REGULATORY INFORMATION DISTRIBUTION SYSTEM (RIDS)

SUBJECT: Documents encl B&WOG 890929 response to NRC 890807 request
 for addl info re NRC Bulletin 88-011, Item 1.b.

DISTRIBUTION CODE: IE30D COPIES RECEIVED: LTR 1 ENCL 1 SIZE: 2 + 29
 TITLE: Bulletin 88-11 Pressurizer Surge Line Thermal Stratification

B&W Owners Group Responses to
NRC Questions on BAW-2085

Figure 1

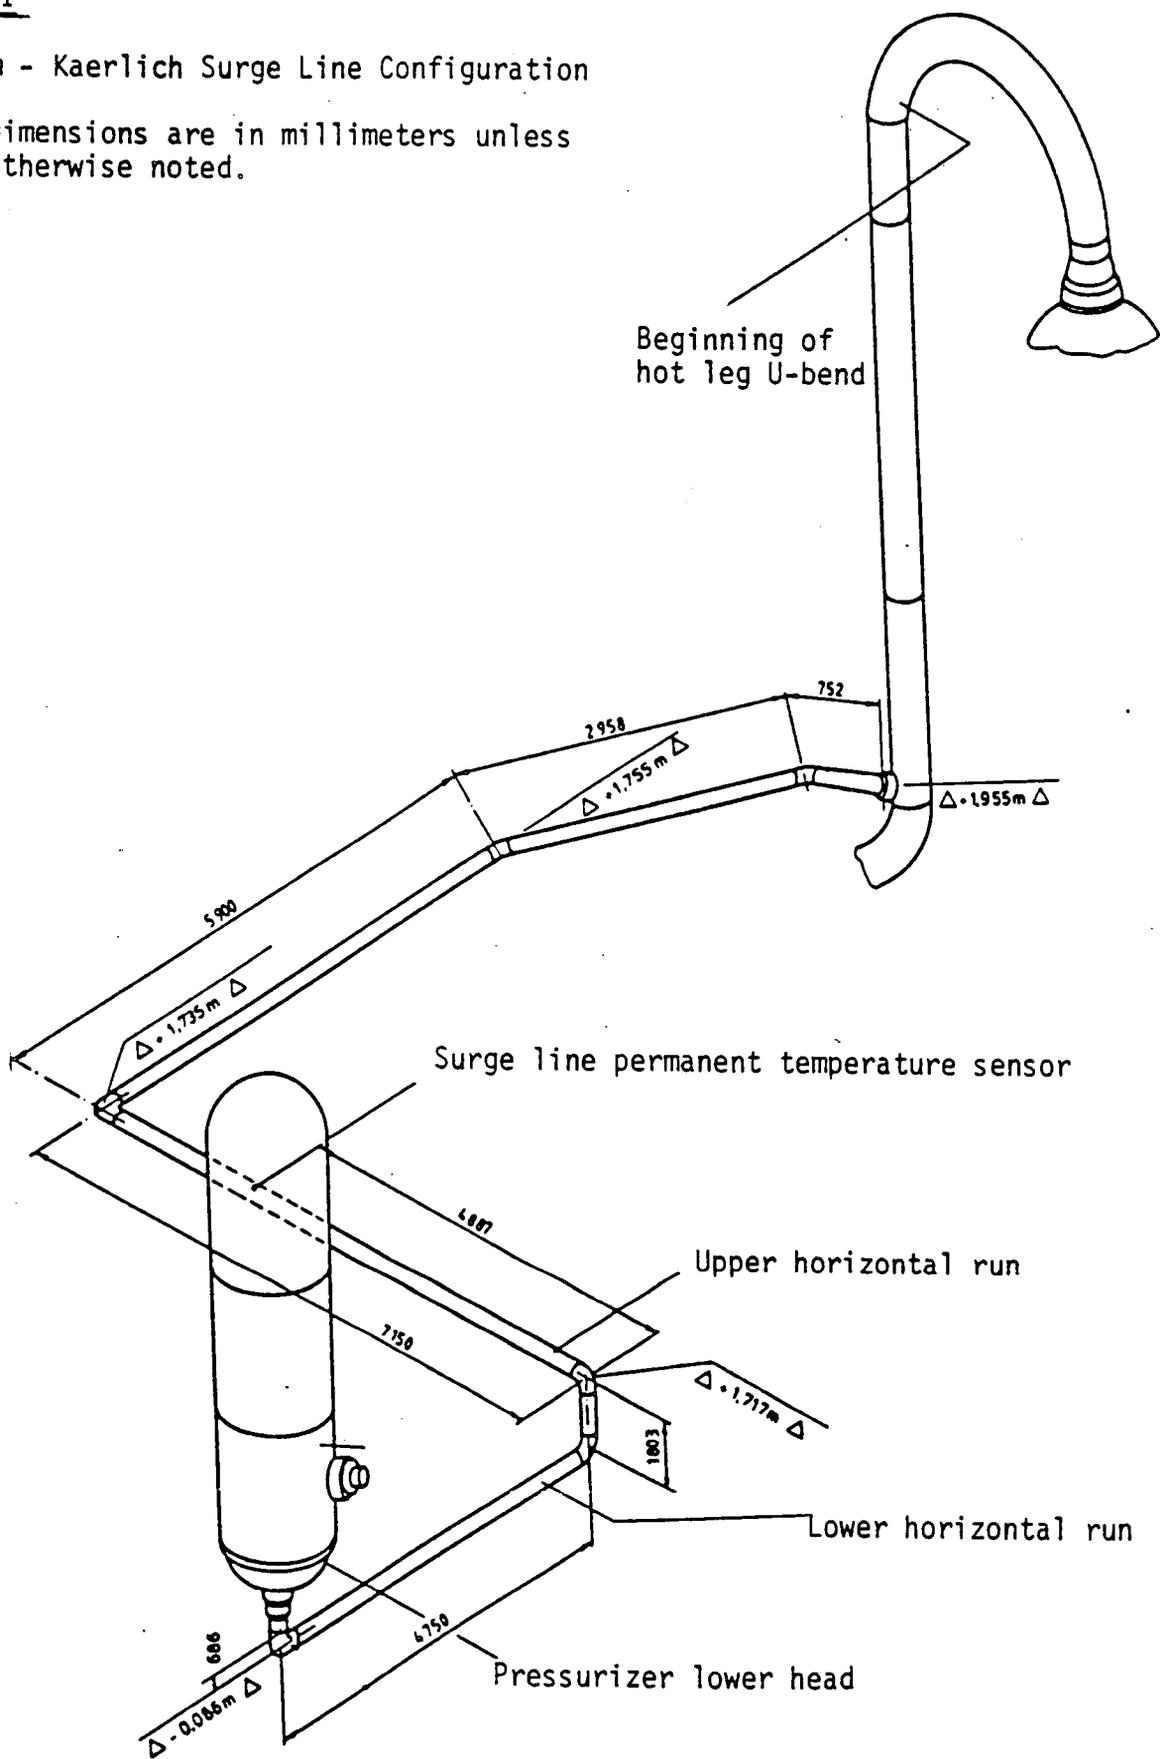
What are the specific differences between the Muelheim-Kaerlich (M-K) plant and the domestic plants?

The M-K plant is a two-loop pressurized water reactor (PWR) with two cold legs in each loop, each with its own reactor coolant pump. The plant employs a pressurizer and associated spray line and surge line functionally similar to typical U.S. PWRs.

The M-K plant's surge line dimensions and configuration are somewhat different from the domestic 177 fuel assembly plants' surge lines. BAW-2085 includes the specific information for the dimensions and configuration of the domestic plant surge lines. Figure 1 shows the M-K surge line configuration. The total line length at M-K is approximately 78 feet compared to about 50 feet for the domestic plants. The M-K configuration also contains a vertical rise in the line about 16 feet away from the pressuri-

zer, somewhat similar to the configuration at the Davis-Besse plant. However, the upper horizontal run at M-K is significantly longer than its counterpart at Davis-Besse.

The surge line inside diameter at M-K is approximately 15.7 inches versus 8.75 inches on the domestic plants. The straight pipe wall thickness at M-K is 1.8 inches versus the domestic plant value of 1 inch. M-K has removable stainless steel insulation on the surge line similar to that manufactured by B&W and used on most of the domestic surge lines.
